Re: RADWP Addendum  
Area A: Sub-Parcel A3-1  
Tradepoint Atlantic  
Sparrows Point, MD 21219

On behalf of EnviroAnalytics Group, LLC (EAG), ARM Group Inc. (ARM) is pleased to submit the following Response and Development Work Plan (RADWP) Addendum to the Maryland Department of the Environment (MDE) and the United States Environmental Protection Agency (USEPA). This RADWP Addendum is being submitted to document several proposed changes to the development project on Sub-Parcel A3-1 (the Site) of the Tradepoint Atlantic property located in Sparrows Point, Maryland.

**Sub-Parcel A3-1 Addendum  
Proposed Work Overview**

**Figure  
1**

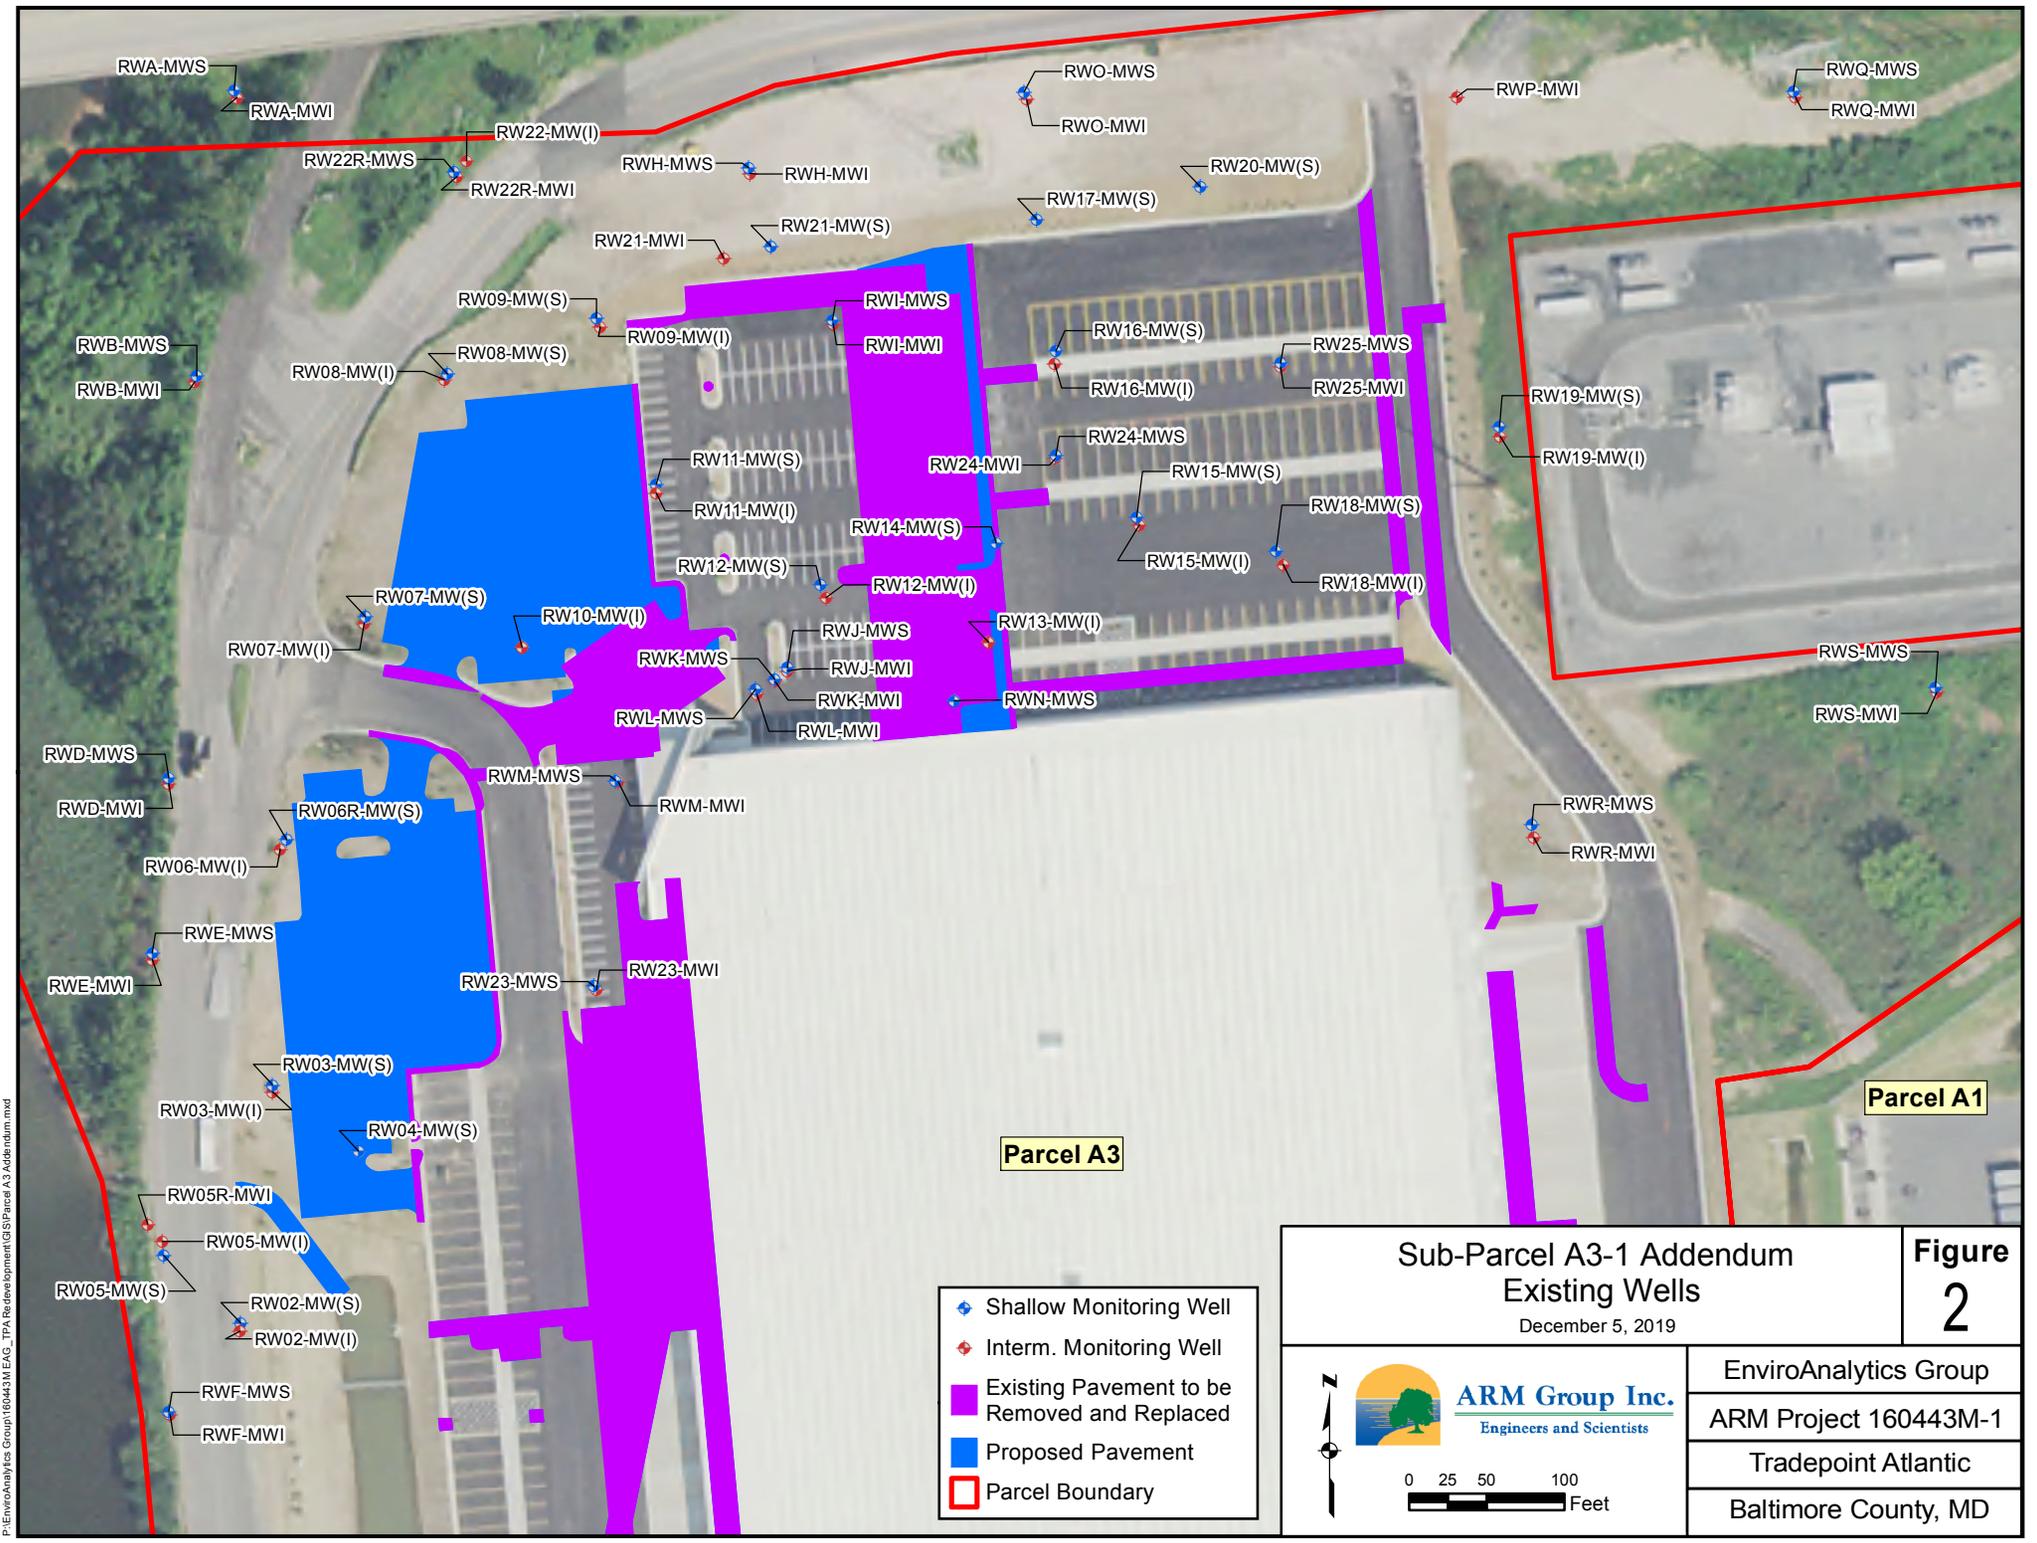
**Figure 1** provides an overview of the proposed work, incorporating the information shown on *Sheet C1.0* through *Sheet C3.1* to indicate the areas of pavement demolition (and subsequent replacement/capping) versus pavement expansion. In several areas, new pavement sections are proposed to be installed overlying existing landscaped caps (as expansions to the current parking areas and access drives) most notably in the northwestern portion of the Site. Further, **Figure 1** shows the horizontal alignments of proposed utilities. Certain utilities are shown outside of the designated pavement areas, indicating that they will be installed below landscaped caps which will be repaired in kind. **Figure 1** is for demonstration purposes; the specific details are shown on the sheets in **Appendix A**.

Sub-Parcel A3-1 Addendum  
Areas of Potential Concern

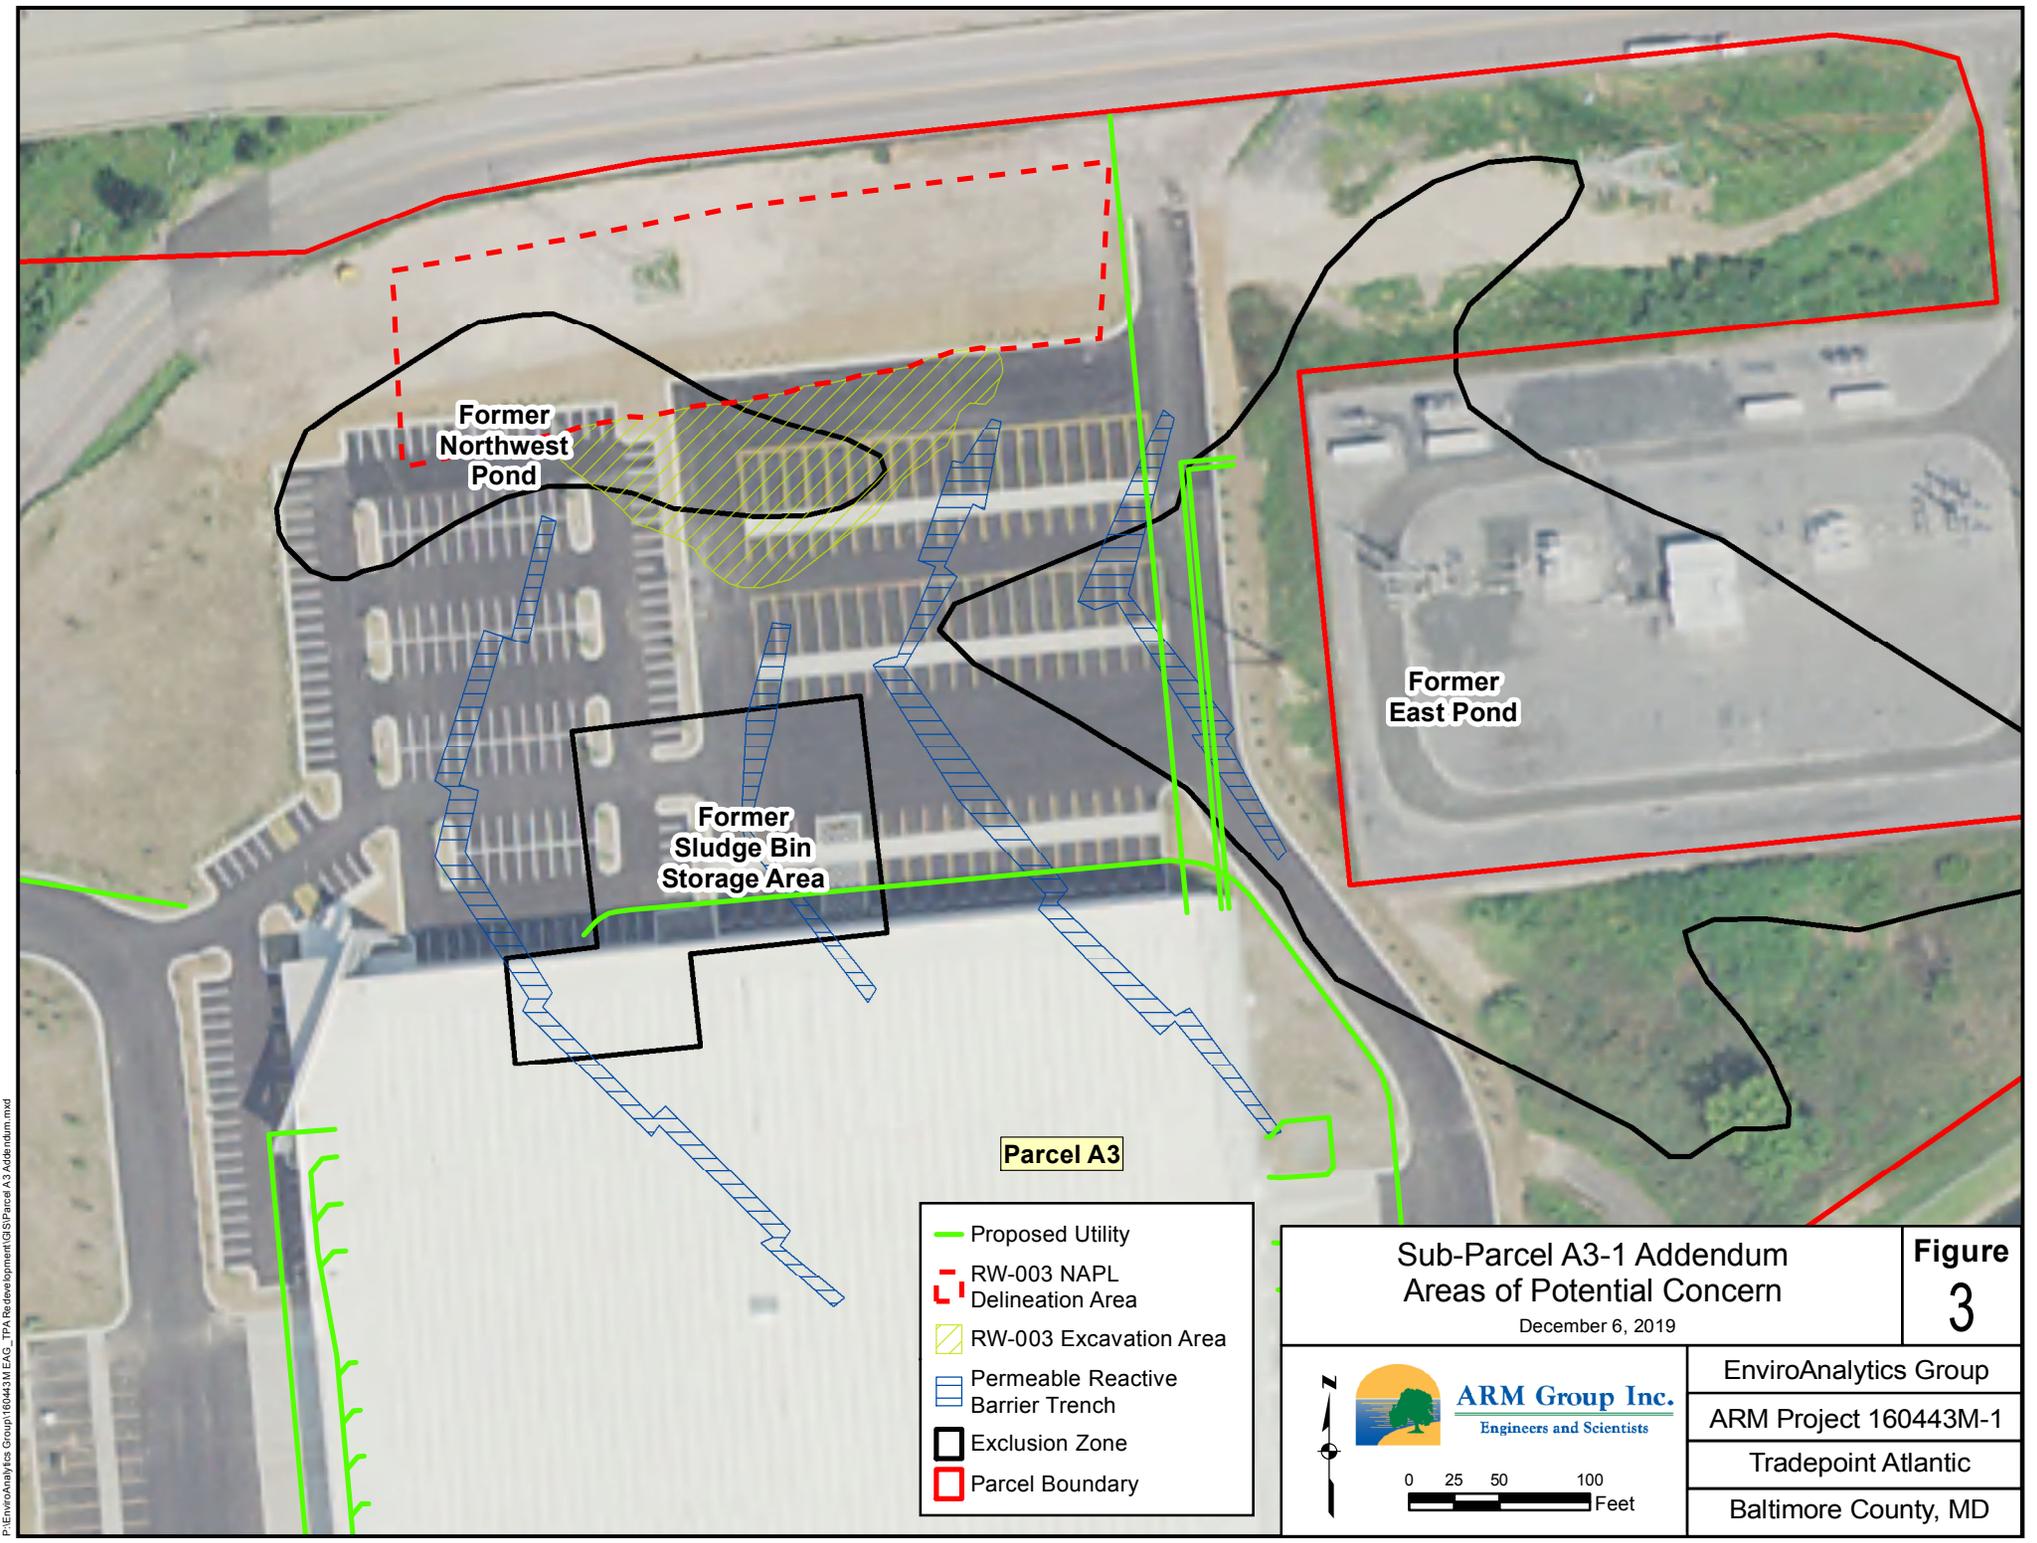
Exclusion Zones were defined in the RADWP as the former East Pond, Sludge Bin Storage Area, and Northwest Pond. The boundaries of these Exclusion Zones are shown on **Figure 3**. As seen on the figure, the proposed utility alignments (specifically gas and electric) extend through portions of the former East Pond and Sludge Bin Storage Area. These utilities will be installed to anticipated depths of less than 5 feet below ground surface (bgs). The use of the Modified Level D PPE as outlined in the approved PPE SOP (**Appendix C**) will prevent potentially unacceptable exposures for Construction Workers performing the required work along these alignments. The EP will also provide continuous monitoring oversight during the excavation of the trenches and installation of the utilities through the Exclusion Zones.

Permeable Reactive Barrier (PRB) Remediation Trenches were installed in the northern portion of Sub-Parcel A3-1 at the locations shown on **Figure 3**. As seen on the figure, the same utility alignments identified above also extend through portions of the trenches. The trenches were constructed using alkaline charge material overlaid by slag backfill. The utility installations are not expected to extend to within the charge material (expected at depths greater than 5 feet bgs).

**SHEET NUMBER**  
**C1.1**  
**PRIVATE DEMO PLAN**

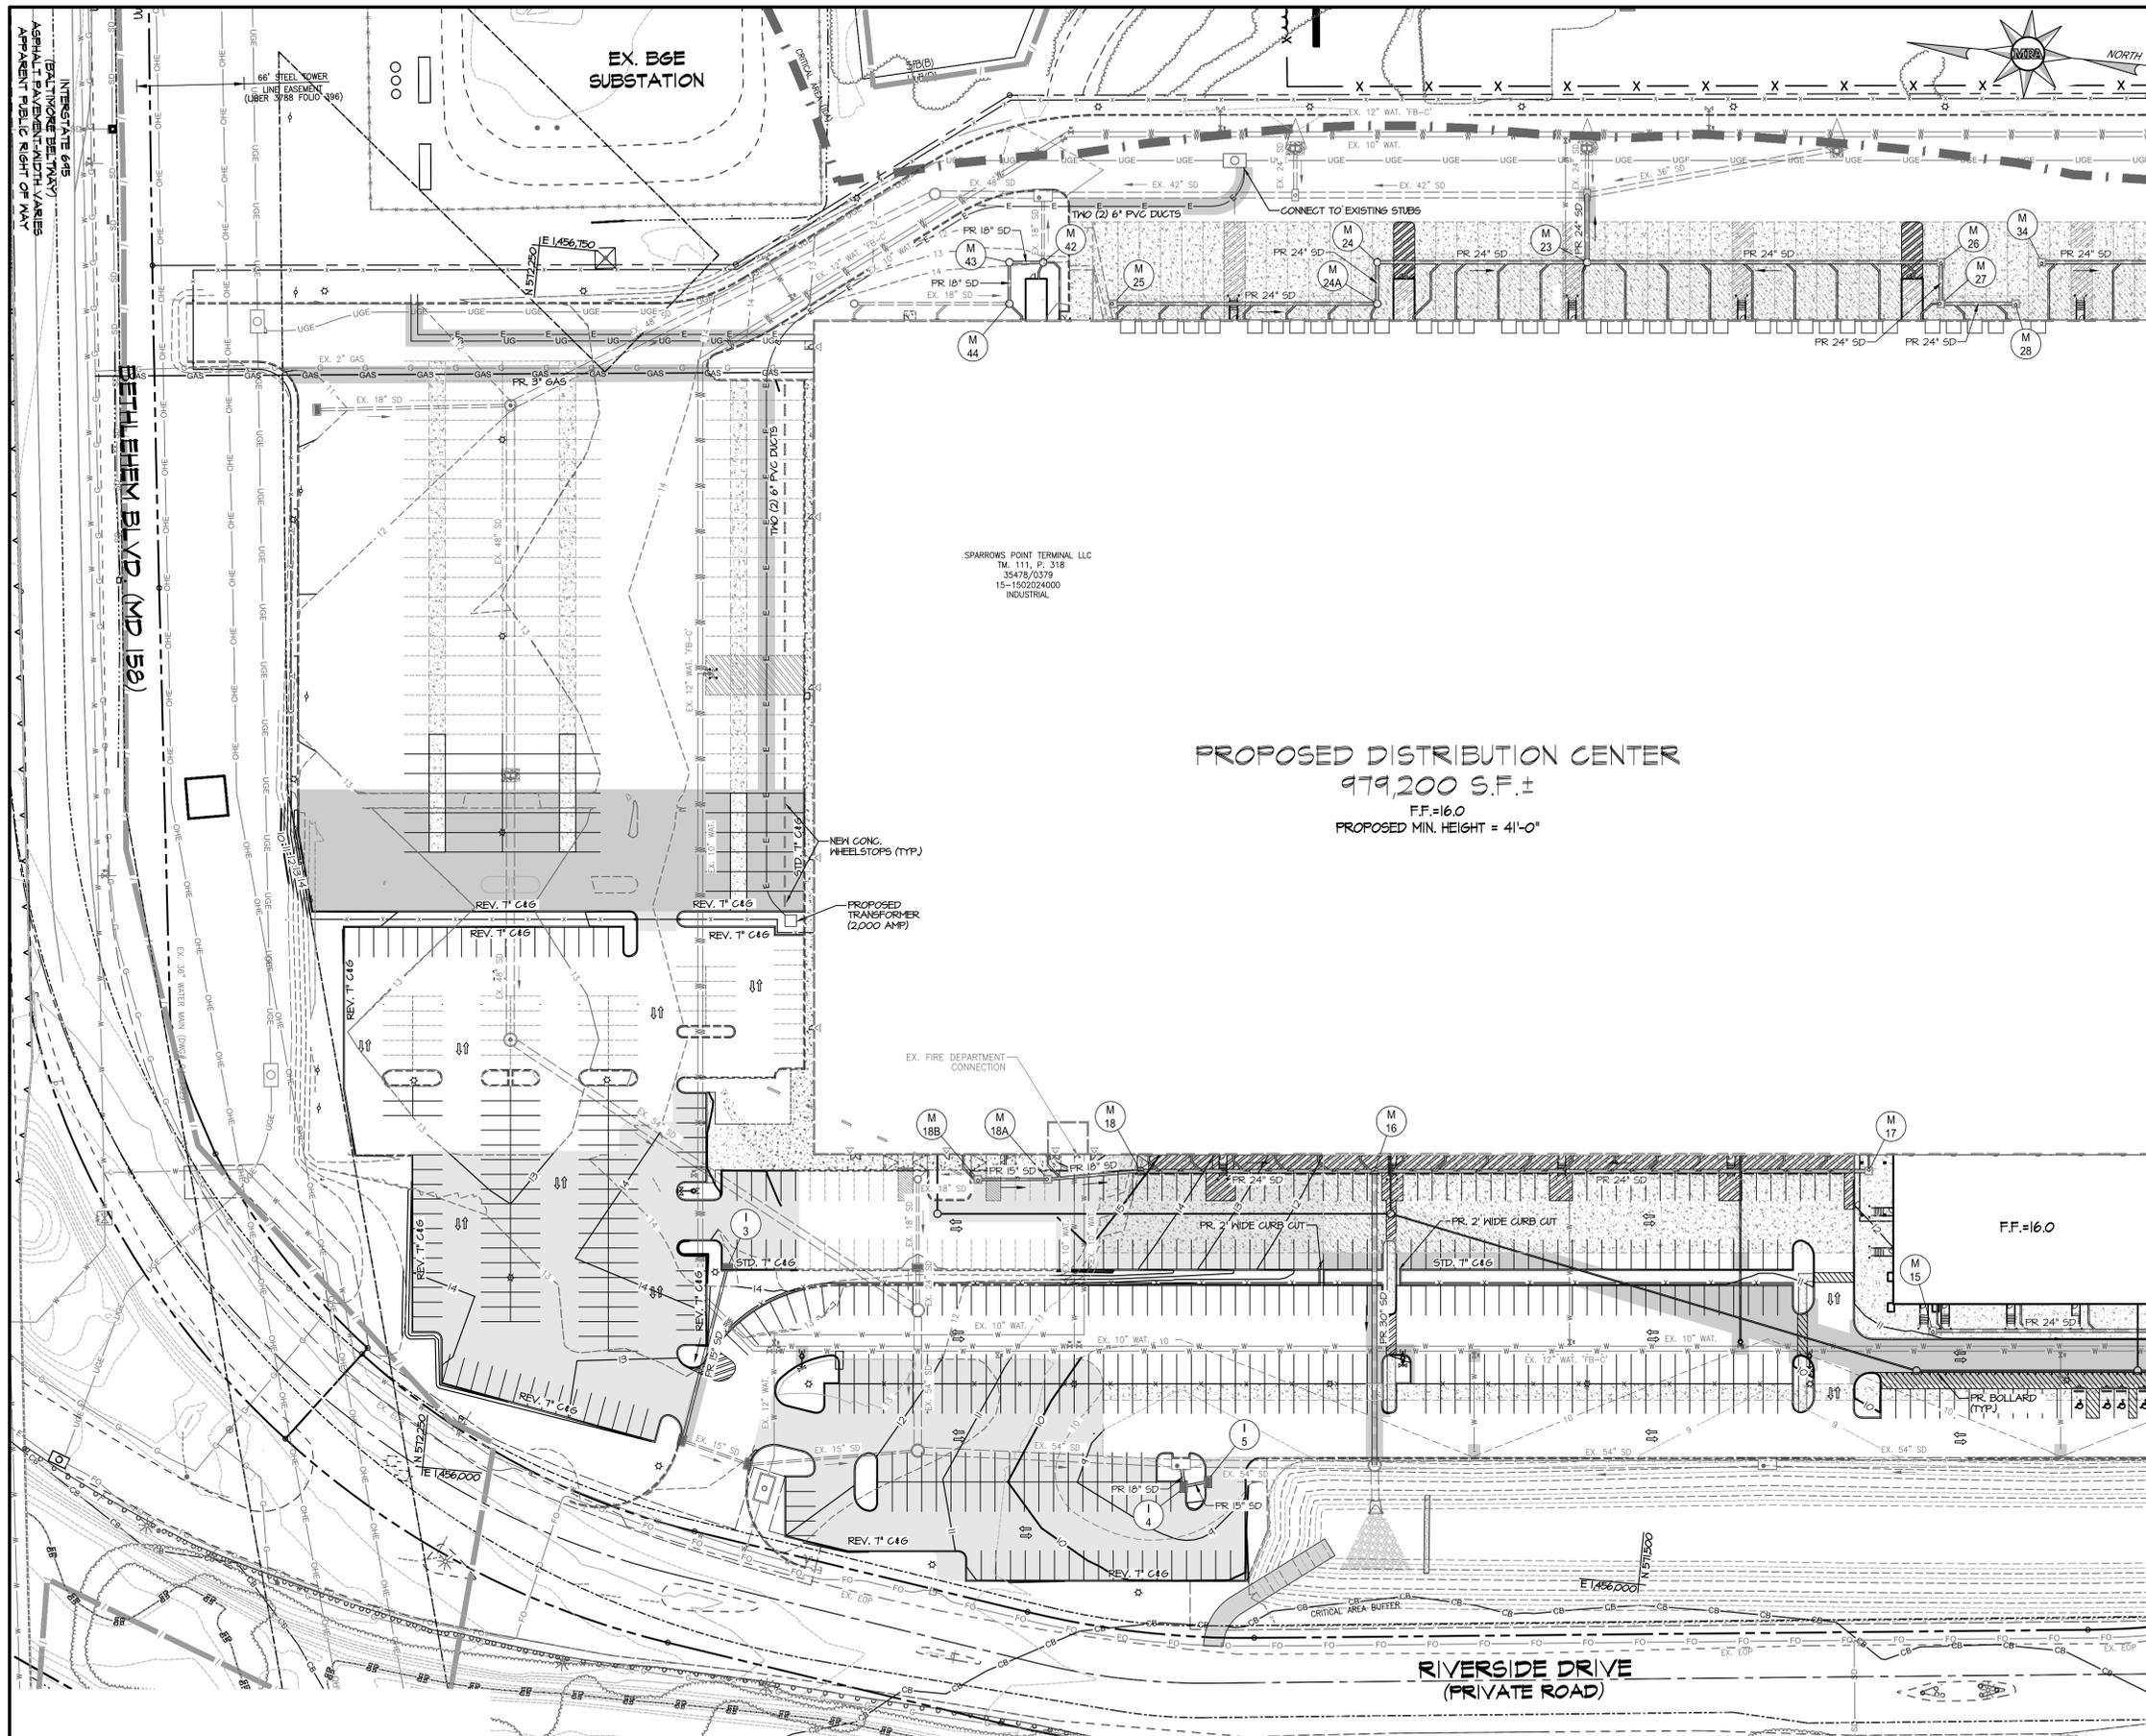
**Appendix A** contains the project construction drawings for the proposed work. *Sheet C1.0* and *Sheet C1.1* highlight the areas where existing pavement, concrete, and curbing are to be removed, and where existing utilities are to be removed or abandoned in place. *Sheet C2.0* and *Sheet C2.1* identify the light- and heavy-duty pavement sections and concrete pavement sections that are proposed to be installed, along with the proposed storm drain plan. *Sheet C3.0* and *Sheet C3.1* provide additional details regarding the proposed water and sanitary sewer plan. The proposed building expansion is also on *Sheet C2.0* through *Sheet C3.1*.
